# UNITED STATES PATENT AND TRADEMARK OFFICE

APPLICATION NO.	FILING DATE	FIRST NAMED INVENTOR	ATTORNEY DOCKET NO.	CONFIRMATION NO.
10/785,353	02/24/2004	Lars Karlsson	ADV4-H61	8962

**Office Action Summary**

## DETAILED ACTION

# APPENDIX

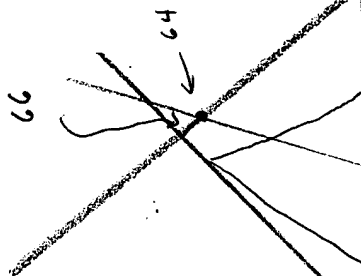
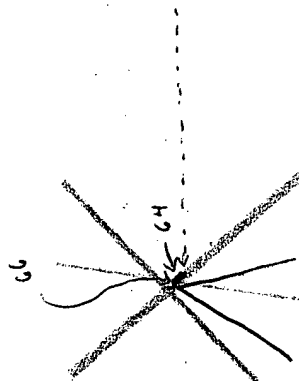
3. Fig. 6, as well as the corresponding description in the specification, is objected to because it is inconsistent with the invention as described in the claims and the rest of the disclosure of the invention. For clarity, attached is an appendix drawing showing what is believed to be the claimed invention. The reference numbers correspond to those given in the flow chart of Fig. 7. The appendix drawing uses an earth-fixed reference frame, so that the transmitter is fixed and the receiver is moving. The first (56A) and second (56B) measurements are used to determine a cross-over point (64). The addition of a third (56C) measurement adds a third line of bearing from which a connecting vector (66) is determined. The portion of the appendix drawing showing second (56B) and third (56C) measurements should correspond to Fig. 6, where Fig. 6 illustrates the situation where the receiver is taken as origin of the coordinate system. Appendix drawing 58B corresponds to Fig. 6 LOB(0). In the earth-fixed frame of the

appendix drawing, the receiver moves left from 56B to 56C. From the receiver's point of view, the transmitter is moving right from PP(0) to PP(1). Thus, it would appear that 52 is a vector whose magnitude and direction represent the motion of the receiver, which is displaced and shown ending at the cross-over point PP(0), where the vector would be a bit off from vector 60C due to the error in measurement of the line of bearing 58C/LOB(1). In other words, 52 is the vector 60C moved to end at the cross-over point, plus the error in measurement. (This is also illustrated by the dotted line to the right of 64 in the appendix drawing, where 52 and the actual connecting vector can be contrasted.) In simplest terms, it does not appear to the examiner that 52 in Fig. 6 corresponds to the connecting vector defined in the rest of the specification and the claims, despite the description that it does on p. 12, line 12. Fig. 6 needs to be corrected or redone.

Corrected drawing sheets in compliance with 37 CFR 1.121(d) are required in reply to the Office action to avoid abandonment of the application. Any amended replacement drawing sheet should include all of the figures appearing on the immediate prior version of the sheet, even if only one figure is being amended. The figure or figure number of an amended drawing should not be labeled as "amended." If a drawing figure is to be canceled, the appropriate figure must be removed from the replacement sheet, and where necessary, the remaining figures must be renumbered and appropriate changes made to the brief description of the several views of the drawings for consistency. Additional replacement sheets may be necessary to show the renumbering of the remaining figures. Each drawing sheet submitted after the filing date of an
